Office Action Summary

10/541,645

DETAILED ACTION

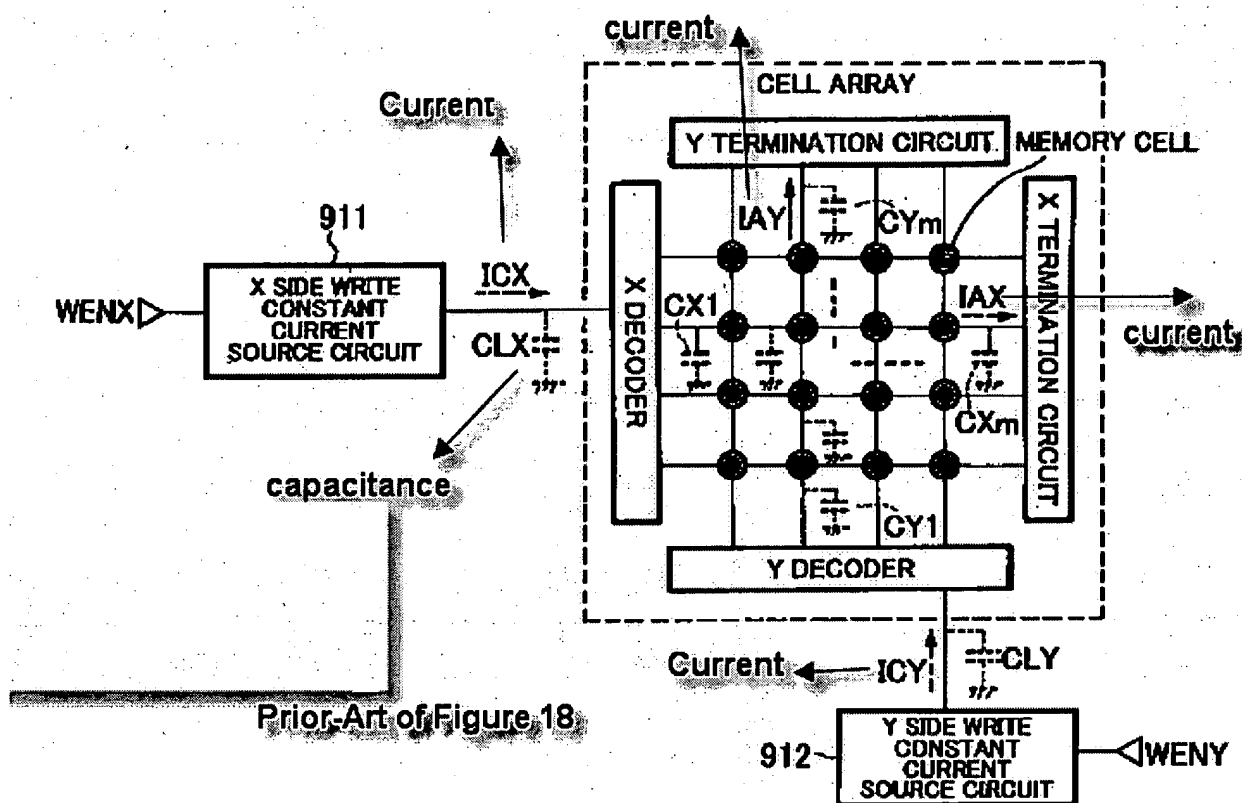
Regarding claim 1, Admission in Figure 18 discloses a semiconductor memory device (MRAM, paragraph 0002, line 5) comprising:

a constant current source (constant current source circuits 911, 912) for writing information into the storage element by flowing current (current flows ICX, ICY) for example, constant current source circuits 911, 912 provide a constant currents output ICX, ICY flow to memory cells through the capacitor CLX, CLY and X-DECODER, Y-DECODER, respectively) at a time when an amount of a current flowed (current flow ICX, ICY) by the constant current source reaches an amount of a current required to write information into the storage element at a predetermined position related to the storage element (for example, a constant current ICX, ICY

output from the constant current source 911, 912 flows in the array of memory cell through the capacitor CLX, CLY for select memory cell, paragraph 0016).

Admission does not disclose a boost circuit for charging parasitic capacitors at a time when an amount of a current flowed the constant current source reaches an amount of a current required to write information into the storage element at a predetermined position related to the storage element.

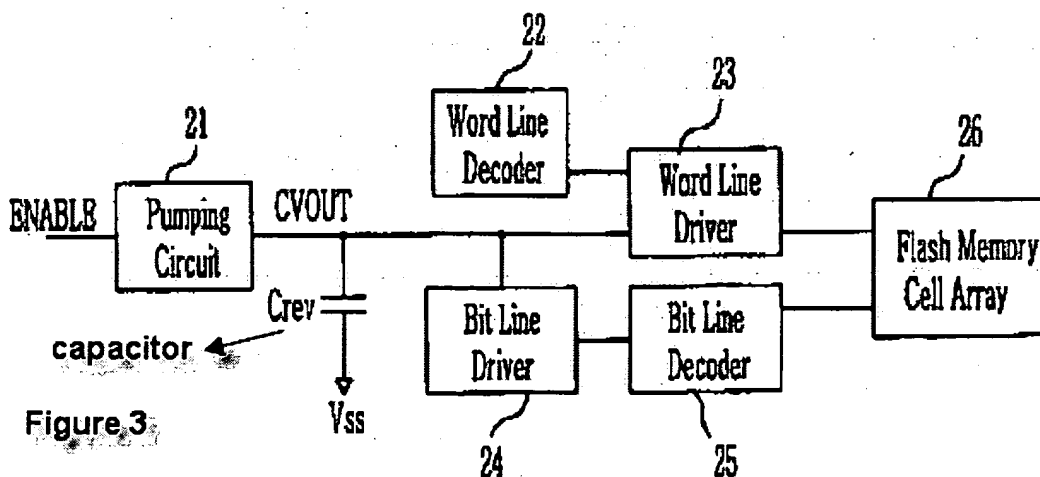
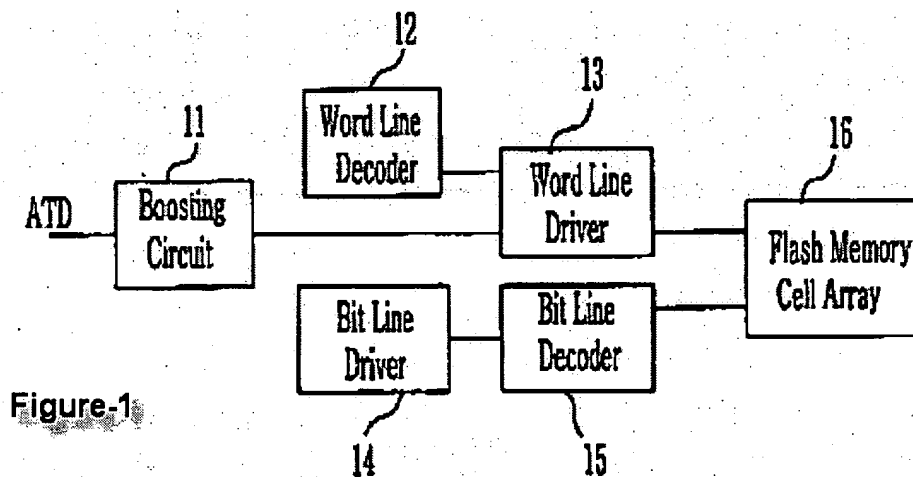
Joo in Figures 1 and 3 discloses a boost circuit (with 11 in Figure 1; and 21 in Figure 3)

for charging parasitic capacitors (**pump circuit 21 charge a capacitor Crev, Figure 3, column 3, lines 10-11**) when an amount of a current flowed the constant current source reaches an amount of a current required to write information into the storage element (select memory cell) (**for example, the reference of Joo in Figure 3 show that pump circuit 21 to generate the output voltage CVOUT coupled to flash memory 26 and it is inherent that the output voltage CVOUT provide the constant current to select cell (store information of memory cell) of flash memory array 26 through the word line driver 23, see column 3, lines 7-13 and lines 21-24**).

Regarding claim 3, Joo in Figures 1 and 3 discloses the semiconductor memory device that the boost circuit (**11, Figure 1 and 21, Figure 3**) comprising a condenser for storing charge to charge the parasitic capacitor (**a parasitic capacitor Cres is a condenser, for example, by definition of capacitor, the capacitor is an electric circuit element used to store charge temporarily, consisting in general of two metallic plates separated and insulated from each other by a dielectric that called condenser**).
